Access Compliance Report

Public Rights-of-Way

(Curb Ramps)

Intersection ID: 21340	Main Street: CHAMPAIGN_ST	Cross Street: SHARON_RD	Location: SE
ADA ID: 81776FF919C2	Ramp Type: PerpDiag	Initial Pass/Fail: Fail	Overall Compliance: No
Severity Score: 33.75			
Codes/Mitigation Info/Possible Solution		Field Measurements/Component Compliance

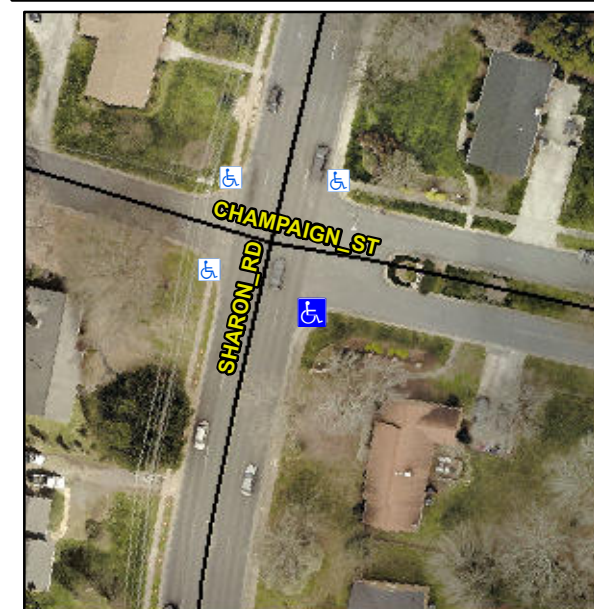
Not Found, R304.5.1, R304.2.2, R304.5.3

Compliance	Description	Data	Compliance	Description	Data
N/A	Ramp Length (in)	60.0	No	Ramp Slope (%)	9.2
No	Ramp Width (in)	42.0	No	Ramp XSlope (%)	6.2
N/A	Flare Type LT	N/A	N/A	Flare Type RT	N/A
N/A	Flare Slope LT (%)	N/A	N/A	Flare Slope RT (%)	N/A
N/A	Flare Traversable LT?	N/A	N/A	Flare Traversable RT?	N/A
N/A	Landing Length (in)	N/A	N/A	DWS Provided?	N/A
N/A	Landing Width (in)	N/A	N/A	DWS Contrast?	N/A
N/A	Landing Slope (%)	N/A	N/A	DWS Length (in)	N/A
N/A	Landing X Slope (%)	N/A	N/A	DWS Full Width?	N/A
N/A	Landing Curb? (Y/N)	N/A	N/A	DWS Offset (in)	N/A
N/A	Shared Landing?	N/A			
N/A	Gutter Ponding?	N/A	N/A	Gutter Slope (%)	N/A
N/A	Gutter Lip Ht (in)	N/A	N/A	Gutter X Slope (%)	N/A
N/A	Painted X Walk1?	No	N/A	Painted X Walk2?	No
	X Walk 1 Direction	To NE		X Walk 2 Direction	To NW
N/A	X Walk 1 Width (in)	N/A	N/A	X Walk 2 Width (in)	N/A
	X Walk 1 Slope (%)	4.6		X Walk 2 Slope (%)	7.0
	X Walk 1 X Slope (%)	6.6		X Walk 2 X Slope (%)	1.8

Remove & Replace Curb Ramp With Two New Directional Ramps or Equivalent.
